DVI OUTPUT EYE DIAGRAMS OF CH7009A/7301A vs. CH7009B/7301B

Scope

Figure 1: Eye-diagram of CH7009A/7301A DVI output at 162 MHz with 3.3V on DVI PLL Power Rail

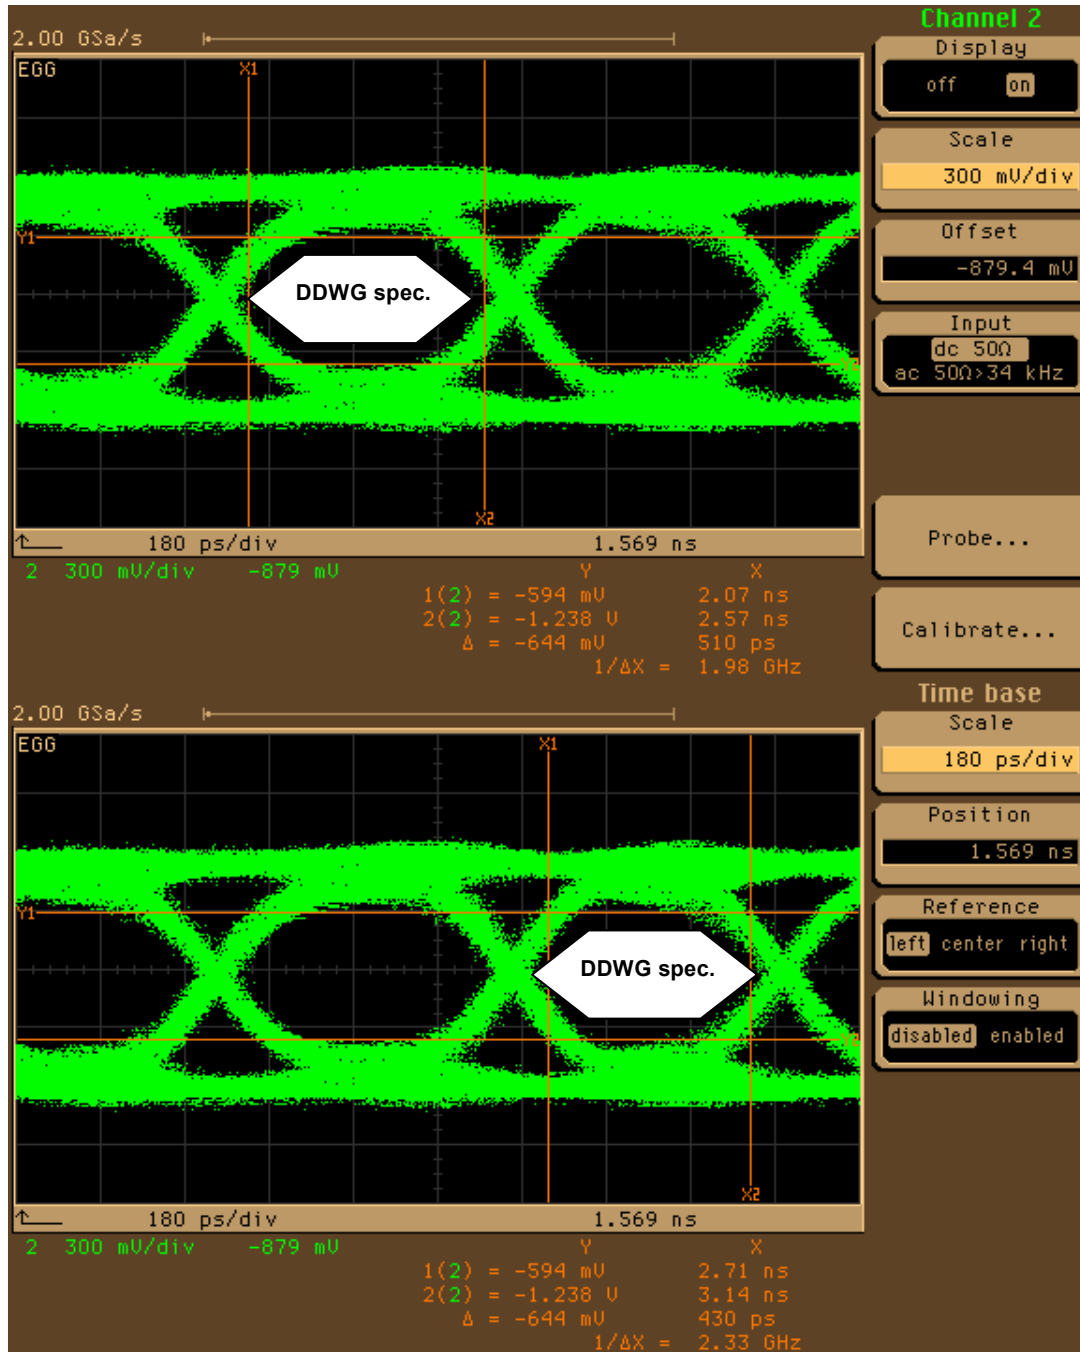
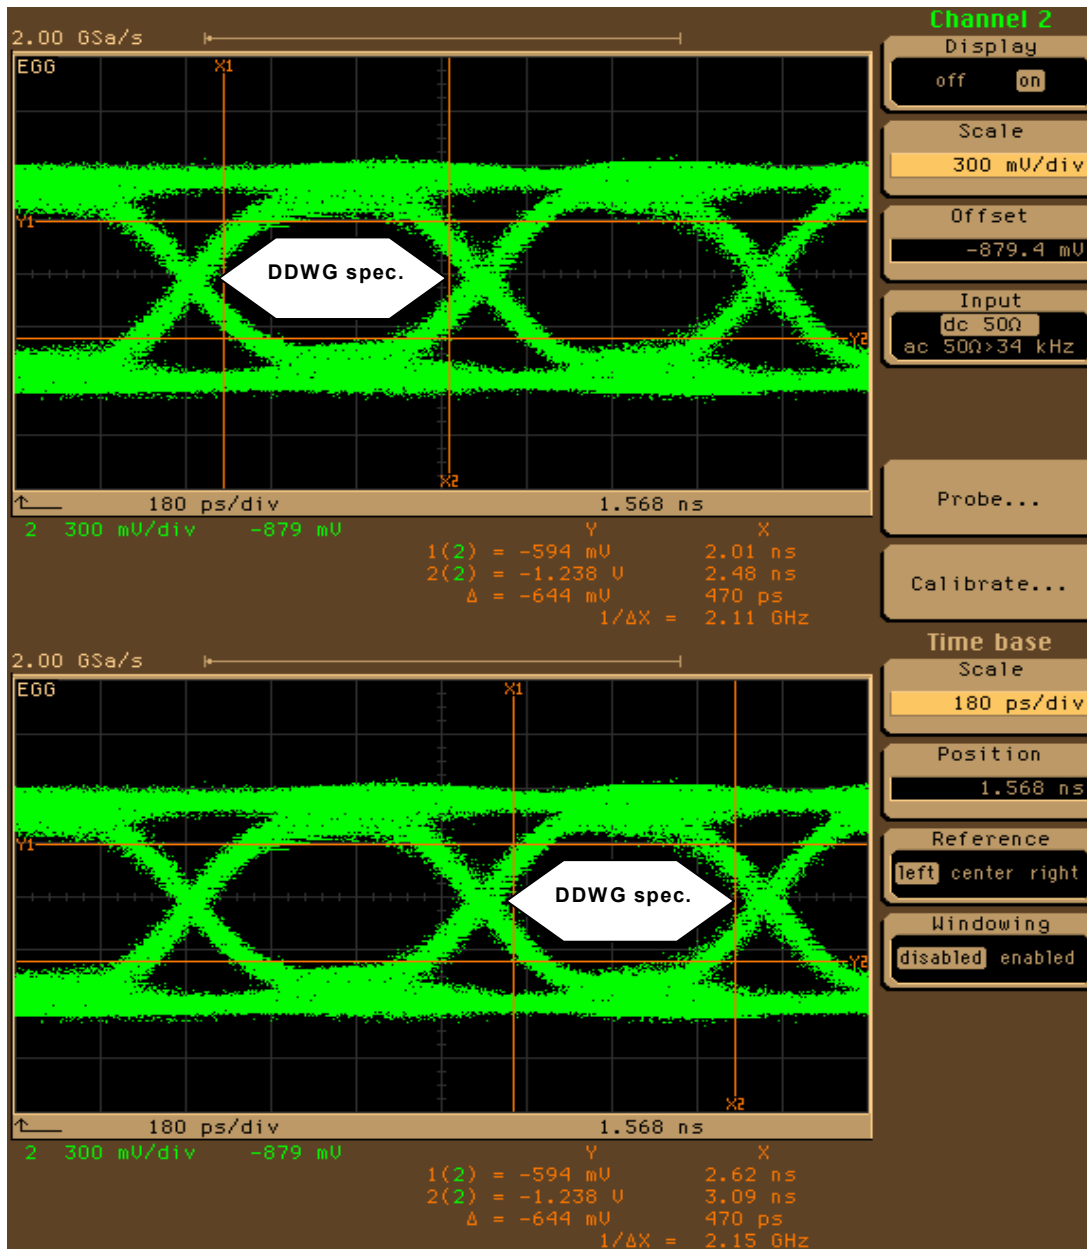
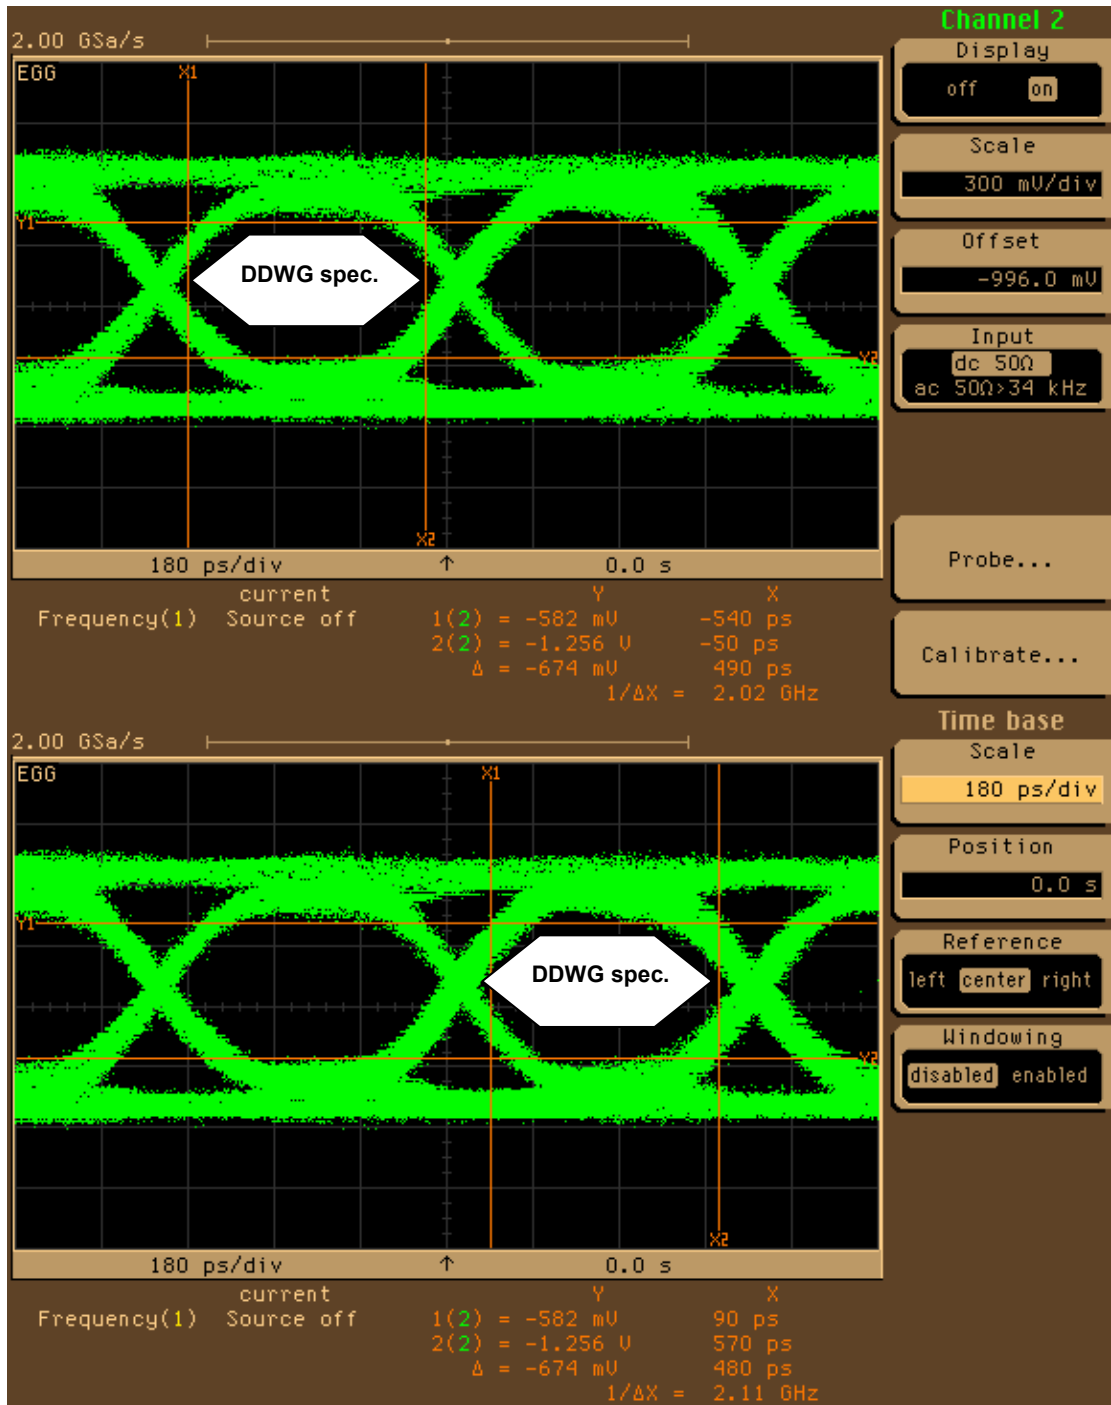
The DVI eye-diagram of some CH7009A/7301A chips may have uneven odd/even eyes when operating under high frequency modes. DVI resolutions such as the 1400 x 1050 pixels or 1600 x 1200 pixels, which require a pixel-clock frequency exceeding 135 MHz, may cause the uneven eye-diagram occurrence. As a result, pixel errors may occur. The uneven DVI eye-diagram comes from the post-VCO level-shifters within the DVI PLL. This phenomenon in CH7009A/7301A is an on-chip statistical processes problem, which has been fixed in the design of their successors, CH7009B/7301B.

Figure 1 shows an uneven odd/even eye-diagram from CH7009A/7301A chips at 162 MHz pixel clock frequency. From a design point of view, this chip should not be used at a frequency higher than 135MHz. A DC balanced duty-cycle screening process has been implemented to screen the CH7009A/7301A chips for running at a frequency up to 165 MHz. In order to retain good stability of the DVI PLL, the DVI PLL power (AVDD) is required to be 3.6V. **Figure 2** shows a well balanced eye-diagram at 162 MHz pixel clock from screened CH7009A/7301A chips. The eye-diagram is DDWG compliant.

A new design of The DVI PLL has been implemented in CH7009B/7301B to correct the uneven eye-diagram problem and enhance the VCO speed. **Figure 3** shows a typical eye-diagram of CH7009B/7301B DVI output operating at 162MHz. The eye-diagram supports that the new chip is robust and is fully DDWG compliant.

Figure 2: Eye-diagram of Screened CH7009A/7301A at 162 MHz with 3.6V on DVI PLL Power Rail
 (Note: It is strongly recommended that the DVI power (AVDD) be 3.6V for pixel clock frequency higher than 135MHz)

Figure 3: Eye-diagram of CH7009B/7301B at 162 MHz with 3.3V on DVI PLL Power Rail

The opening amplitude is 674mv and extreme horizontal openings are 490ps, and 480ps respectively. It complies with DDWG specification.
